## ADDENDUM

# 02 | 250117

### School District of Lancaster

McCaskey High School Stadium Projects  
Lancaster, PA

ASK-01

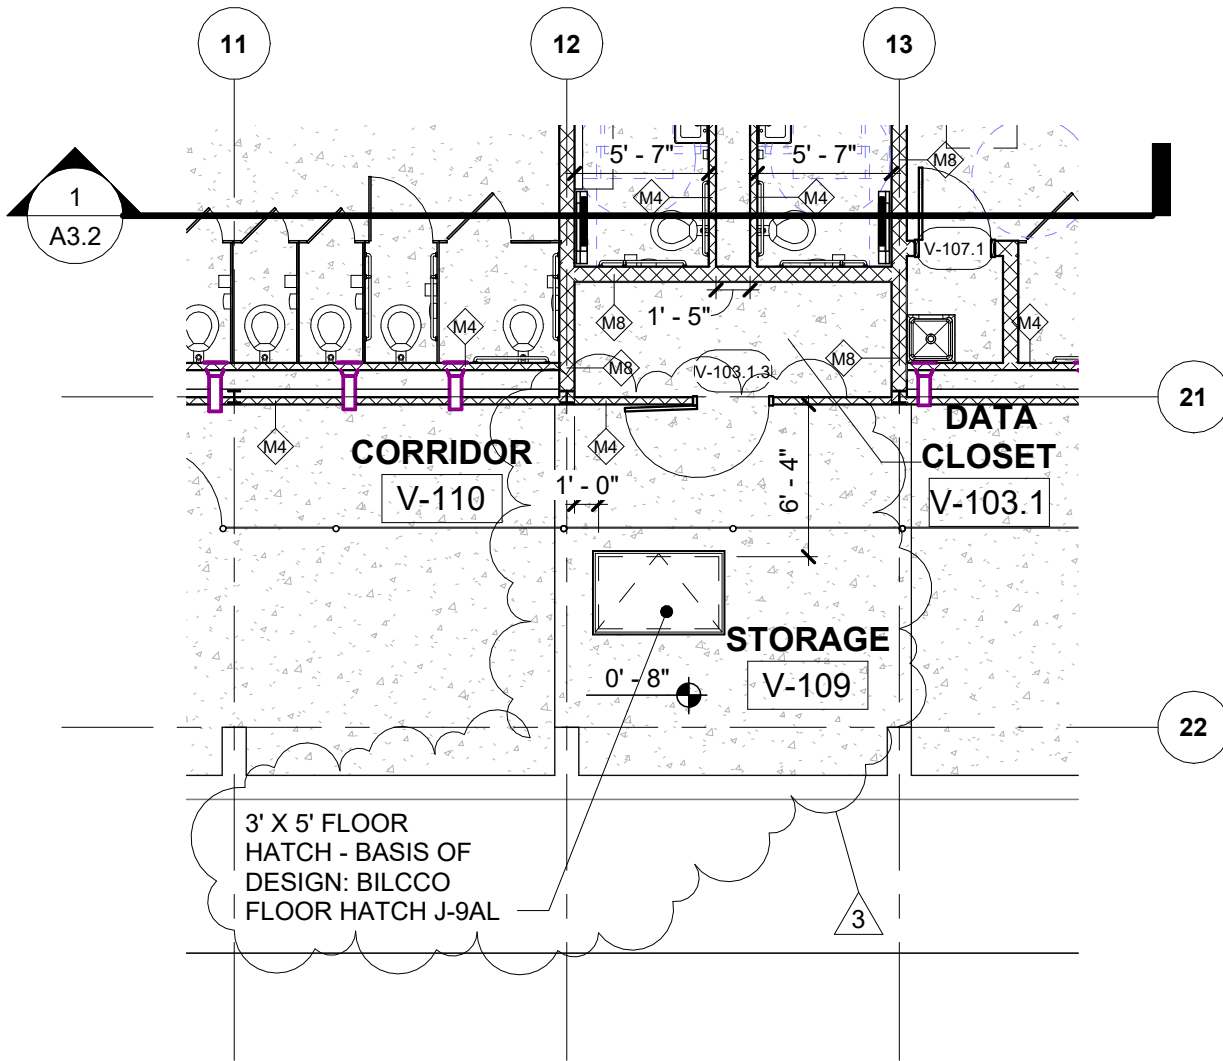
- a. DELETE Manhole located in Storage V-109.
- b. ADD Floor hatch in Storage V-109 – Refer to sketch ASK-01
- c. ADD concrete hatch pattern to stairs located in ENTRY V-111.

**1 ENLARGED PLAN**  
ASK-02 1/4" = 1'-0"

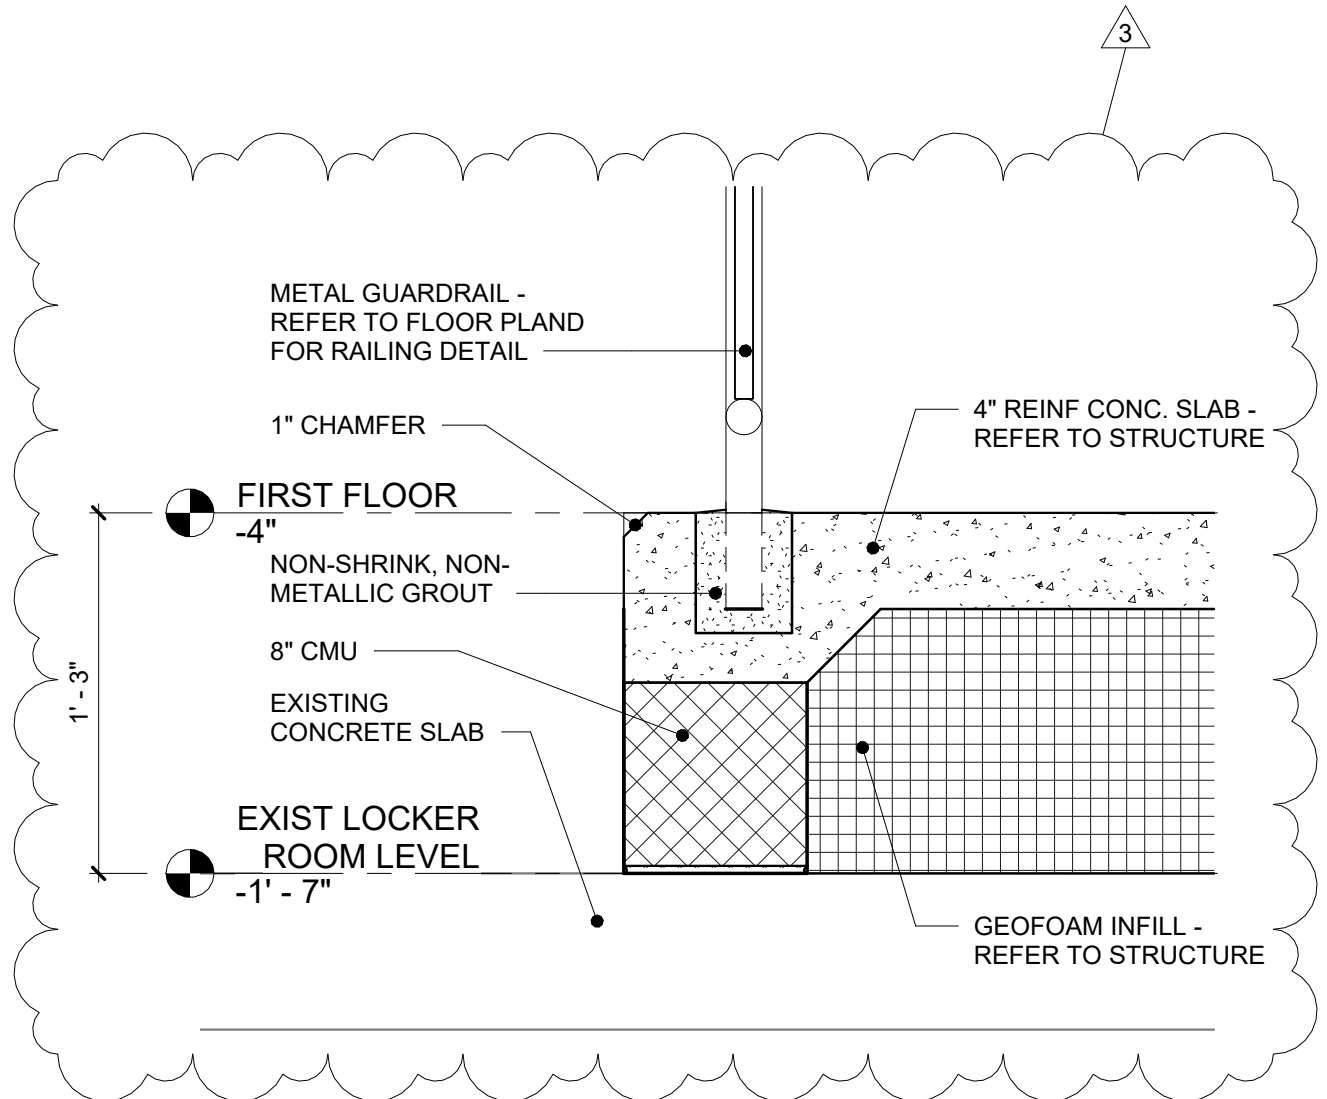
- a. Refer to plan 3/A7.2. REVISE plan layout – Refer to ASK-02
- b. Refer to detail 9/A7.2. REVISE note of center rail to read as '1 1/2" DIA MTL PIPE INTERMEDIATE RAIL – TYP'
- c. Refer to detail 11/A7.2. ADD note '1 1/2" DIA MTL PIPE INTERMEDIATE RAIL, PAINT – TYP' to center rail.
- d. Refer to detail 12/A7.2. REVISE note of center rail to read as '1 1/2" DIA MTL PIPE INTERMEDIATE RAIL – TYP'.

REFER TO PLAN 3/A7.2

**2 SECTION DETAIL**  
ASK-02 1 1/2" = 1'-0"

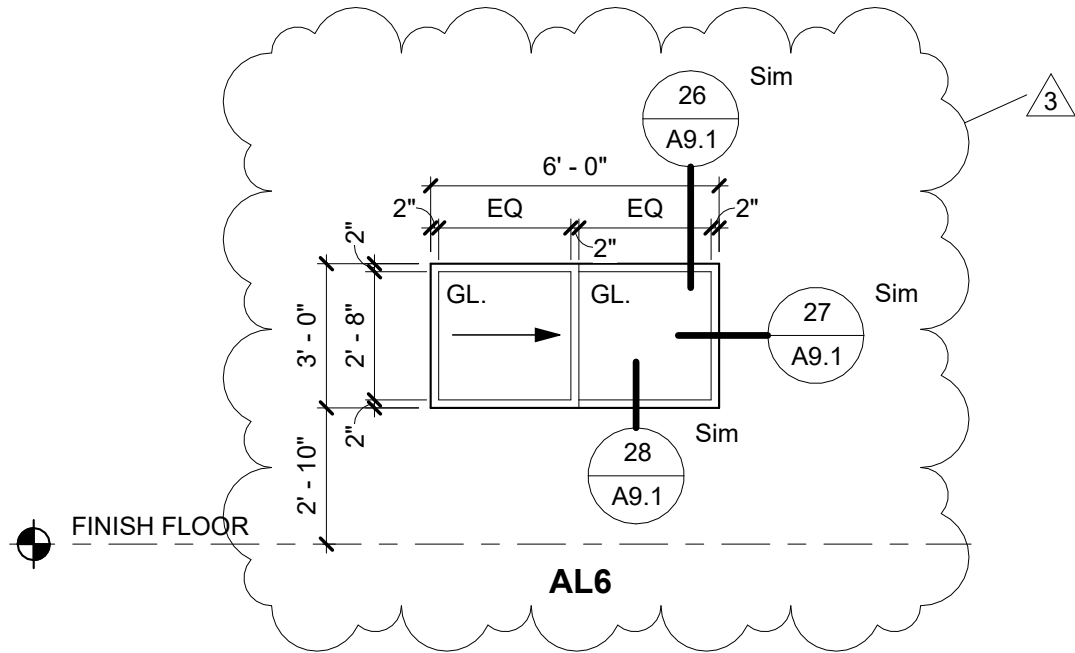
02.13 Refer to Drawings A1.3 – SECOND FLOOR PLAN. ADD Detail 6/A1.3 SECTION DETAIL. Refer to sketch ASK-02.

REFER TO PLAN 6/A1.3

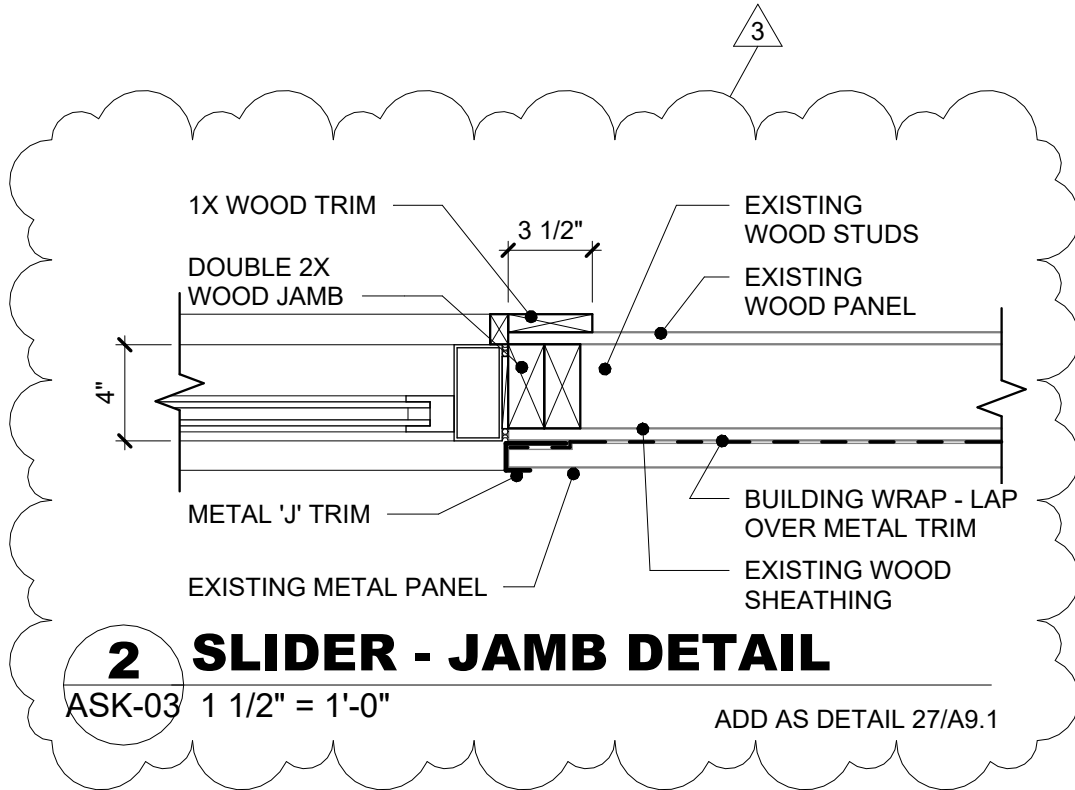
- a. Refer to ALUMINUM FRAME TYPES – ADD Frame type AL6 - Refer to ASK-03.
- b. ADD detail 26/A9.1, 27/A9.1 and 28/A9.1 – Refer to ASK-03.

ADD AS ALUMINIUM FRAME TYPE AL6 ON SHEET A9.1

SECTION @ PIT  
SCALE: 1/2" = 1'-0"

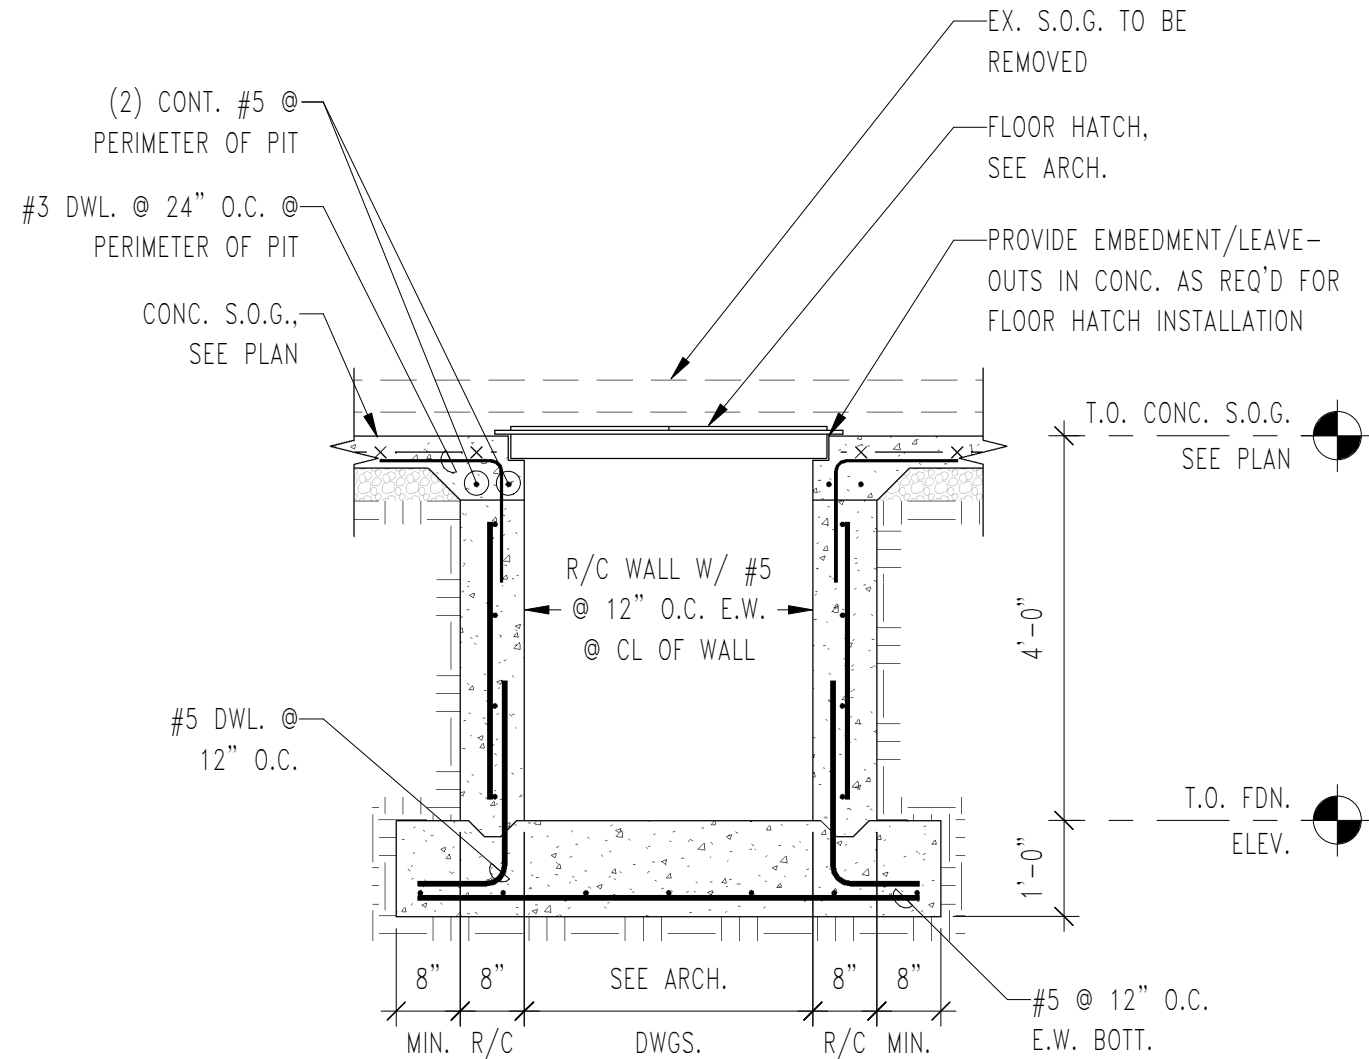
- a. ADD section detail 9/S2.3 "SECTION @ PIT" to drawing S2.3 per the attached SSK-02.

SKETCH SHEET REFERENCE DWG. NUMBER: 9/S2.3
